***ESCHERICHIA COLI* TOTAL MAXIMUM DAILY
LOAD EVALUATION OF PIERRE CREEK,
HANSON COUNTY, SOUTH DAKOTA**

Re: TMDL Approvals
Pierre Creek, E. coli; SD-JA-R-PIERRE_01

EPA REGION VIII TMDL REVIEW

Document Name:	Escherichia Coli Total Maximum Daily Load Evaluation of Pierre Creek, Hanson County, South Dakota
Submitted by:	Rich Hanson, SD DENR
Date Received:	October 19, 2011
Review Date:	November 30, 2011
Reviewer:	Vern Berry, EPA
Rough Draft / Public Notice / Final?	Final
Notes:

Figure 3. Listed segment of Pierre Creek, including sampling sites and potential pollutant source locations.

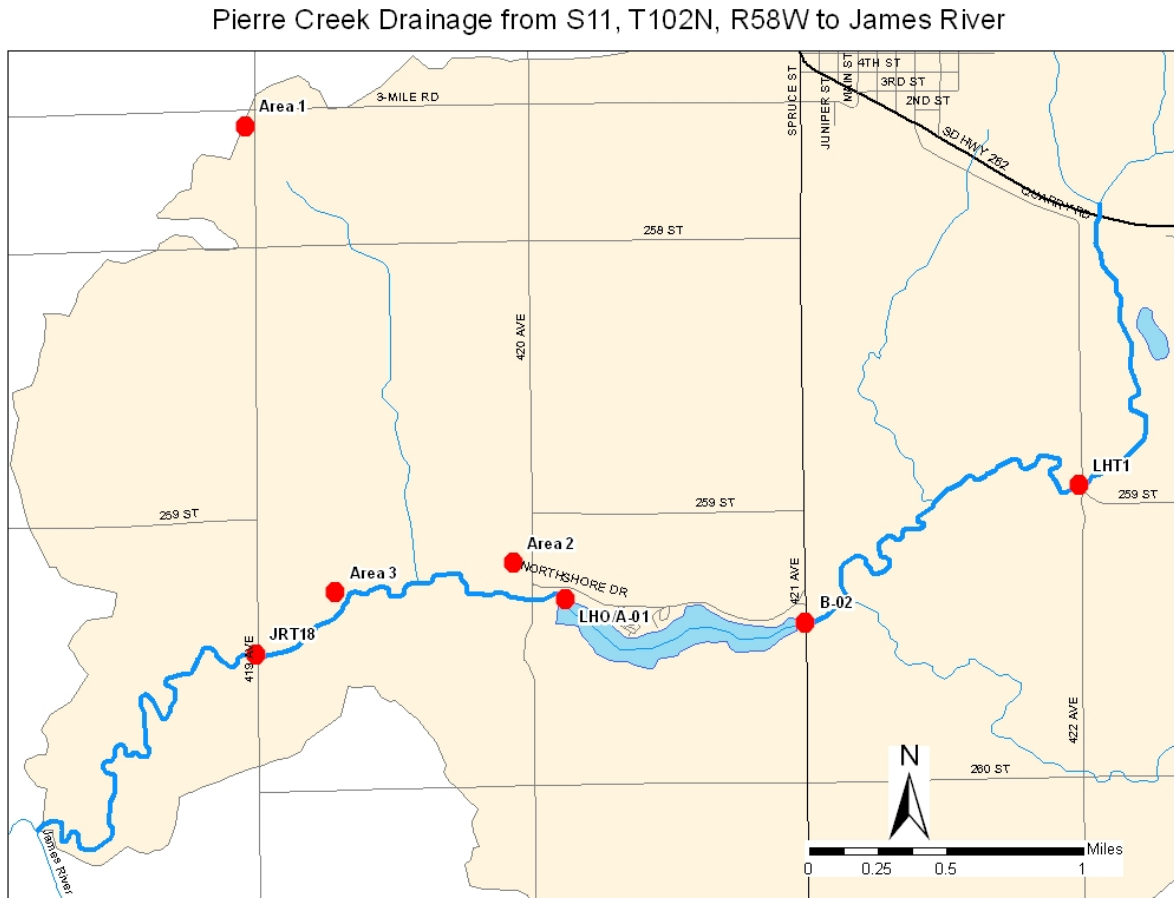
Aerial photos were used to locate three potential sources of bacterial contamination (see Figure 3 of the TMDL document) within the immediate drainage area of monitoring site JRT18. Area 1, an animal feeding operation, was ruled out as a source because the tributary to Pierre Creek indicated on the map was not detectable on the ground and thus, there is no direct route for bacteria to reach Pierre Creek. There was no evidence of significant livestock near Area 2. A livestock feeder was found near Pierre Creek at Area 3 on the map. At the time of inspection there were no cattle present at Area 3, however, visual evidence indicated heavy cattle use. There was evidence of trampling and fecal matter in a large area close to the stream. It is most likely that this is the predominant source of E. coli contamination between Lake Hanson and monitoring site JRT 18.

Figure 5. Load duration curve for the listed segment of Pierre Creek.

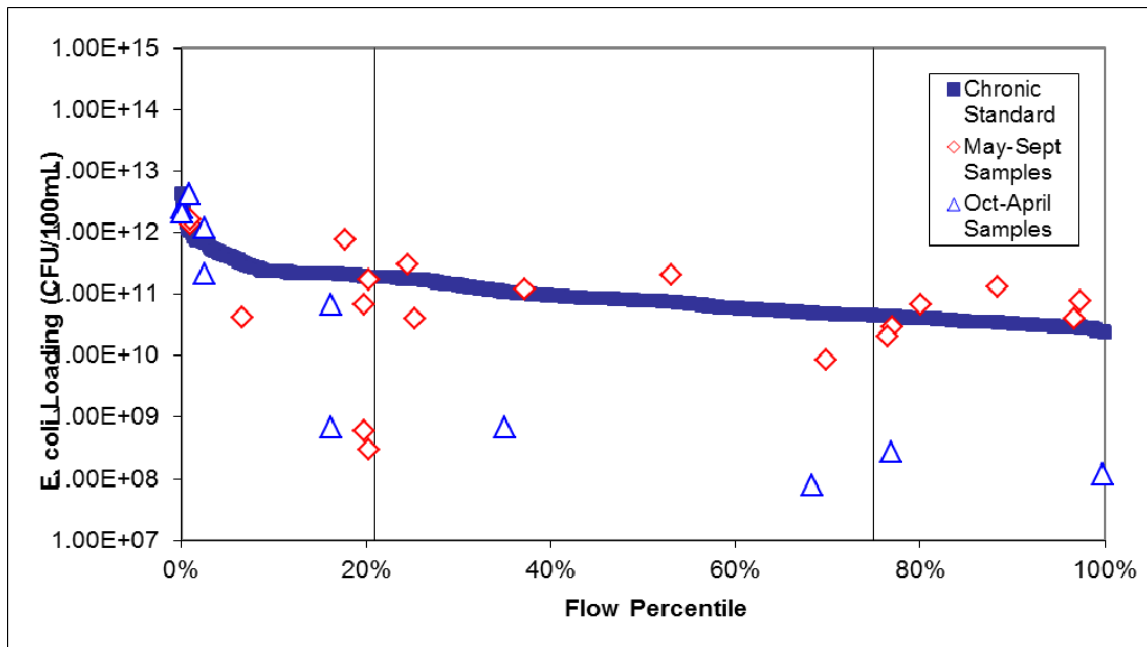
regime shown in Figure 5 of the TMDL document. The LDC is a dynamic expression of the allowable load for any given daily flow. Instantaneous loads were calculated by multiplying the E. coli sample concentrations, discharge data, and a unit conversion factor. When the instantaneous loads are plotted on the LDC, characteristics of the water quality impairment are shown. Instantaneous loads that plot above the curve are exceeding the TMDL, while those below the curve are in compliance. As the LDC shows, E. coli samples collected from Pierre Creek violated the TMDL target in all three flow zones. To ensure that both the acute and chronic E. coli standards are met, reductions were calculated using the TMDL target of 630 colonies/100mL, resulting in reductions in all 3 flow zones. Loading capacities were derived from this approach for each flow regime: high flow = 1.06E+12 cfu/day; midrange flow = 1.79E+11 cfu/day; and groundwater flow = 4.35E+10 cfu/day.
